Project	IEEE 802.16 Broadband Wireless Access Working Group < http://ieee802.org/16 >	
Title	Comment on Unsolicited RNG-RSP in transparent RS System	
Date Submitted	2007-07-05	
Source(s)	Kanchei (Ken) Loa, Yi-Hsueh Tsai, Yung-Ting Lee, Hua-Chiang Yin, Shiann-Tsong Sheu, Youn-Tai Lee,	Voice: +886-2-27399616 Fax: +886-2-23782328 loa@iii.org.tw
	Institute for Information Industry 8F, No. 218, Sec. 2, Dunhua S. Rd., Taipei City 106, Taiwan	
Re:	IEEE 802.16j-07/019: "Call for Technical Comments Regarding IEEE Project 802.16j"	
Abstract	This contribution proposes the modified figures of MS unsolicited RNG-RSP in non-transparent RS system under centralized scheduling scheme based on comment #1141 of 80216j-07_014r4.cmt.	
Purpose	Text proposal for 802.16j Baseline Document.	
Notice	<i>This document does not represent the agreed views of the IEEE 802.16 Working Group or any of its subgroups. It represents only the views of the participants listed in the "Source(s)" field above. It is offered as a basis for discussion. It is not binding on the contributor(s), who reserve(s) the right to add, amend or withdraw material contained herein.</i>

Comment on Unsolicited RNG-RSP in transparent RS Sy

Table 201d—Unsolicited RNG-RSP triggered by upstream traffic in non-transparent ~~RS system mode~~

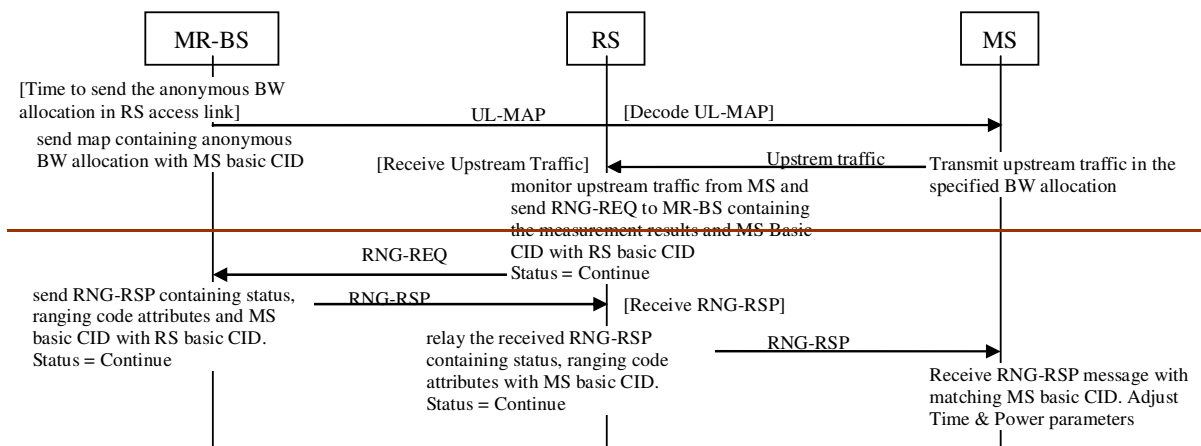
[Replaced the following Table 201d in page 201d as indicated]

Figure 108f—Unsolicited RNG-RSP in Transparent RS system triggered by upstream traffic at Transparent Access RS

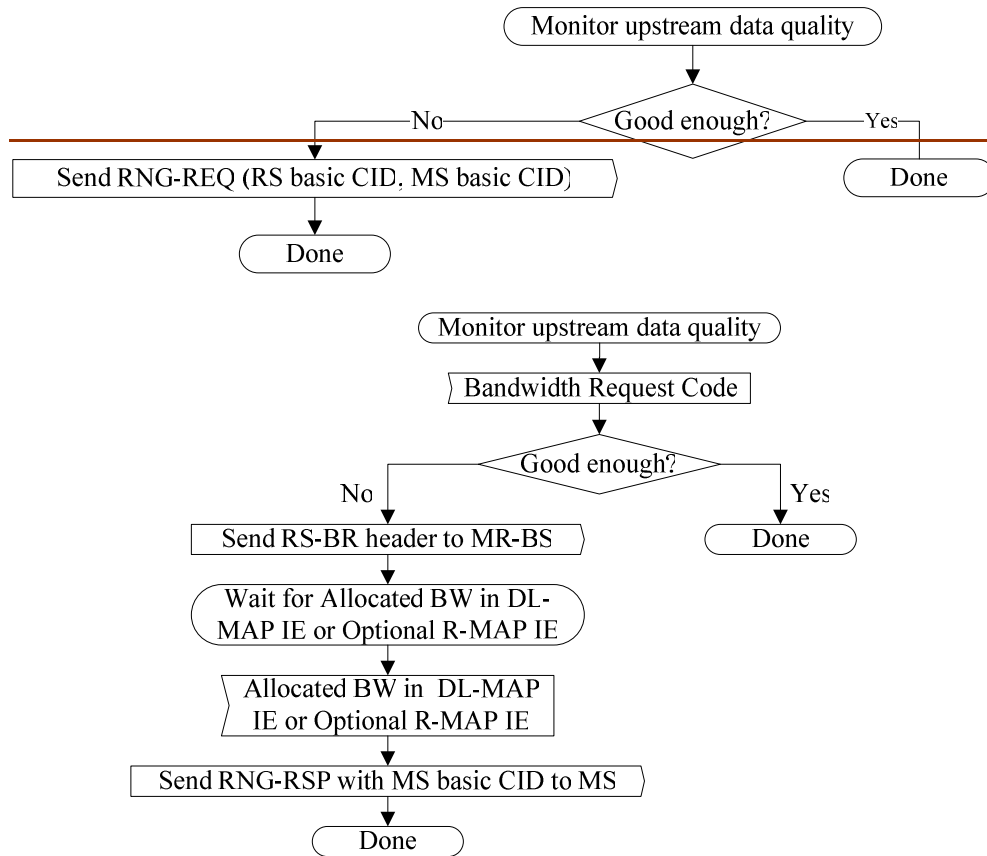
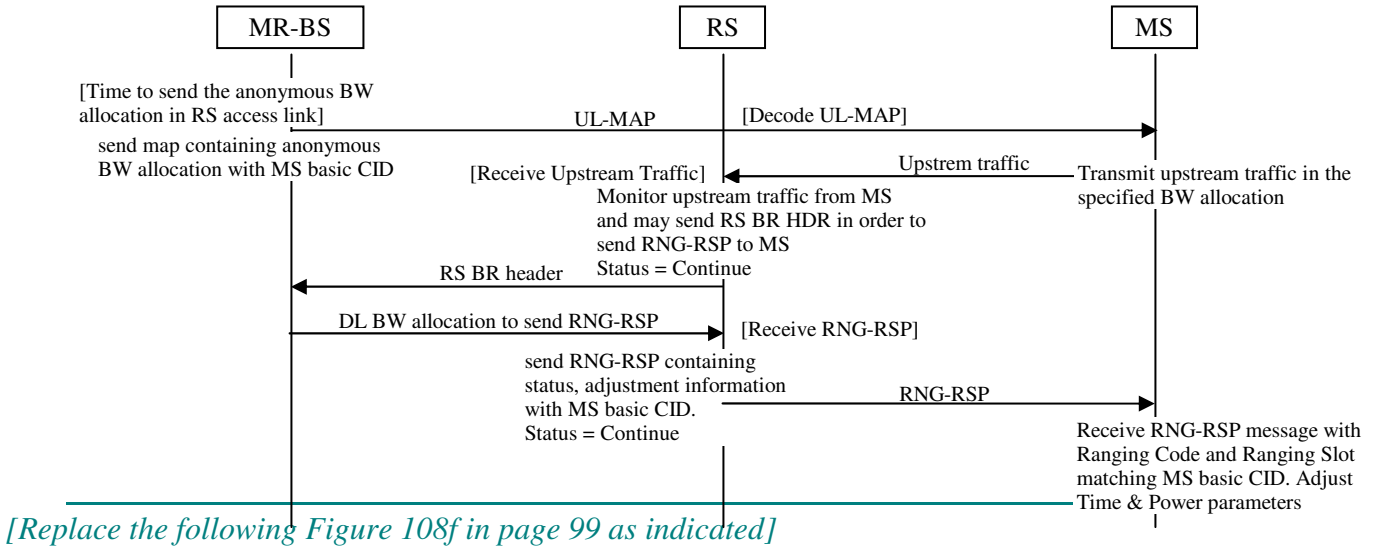
When the offsets of frequency, power, and timing for any other data transmission from the MS are beyond the tolerance defined in this specification, RSs may transmit an unsolicited RNG-RSP with continue status to MS on access link in optional transparent zone. In order to send RNG-RSP to MS on the access link, RS sends a RS BR header to MR-BS. ~~shall may transmit a RNG-REQ message with the RS basic CID containing the MS basic CID to the serving MR-BS through the relay path.~~

The message sequence charts (Table 201d ~~xxx~~ and Table ~~yyy~~201e) and flow charts ([Figure 108f](#), [Figure 108g](#), [Figure ~~xxx~~108h](#) and [Figure ~~yyy~~108i](#)) define the unsolicited RNG-RSP process that shall be followed by compliant RSs and MR-BSs.

Figure 108g—Unsolicited RNG-RSP ~~in Transparent RS system~~ triggered by upstream traffic in transparent mode at MR-BS

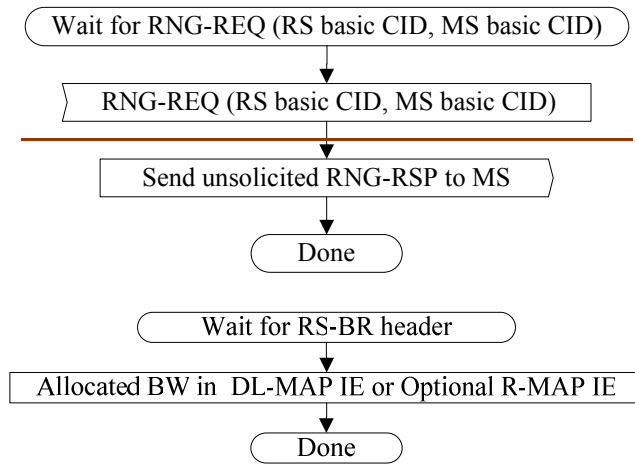
~~Upon receiving the RNG-REQ message from a subordinate RS, the MR-BS may send an unsolicited RNG-RSP message with this MS basic CID to the MS.~~
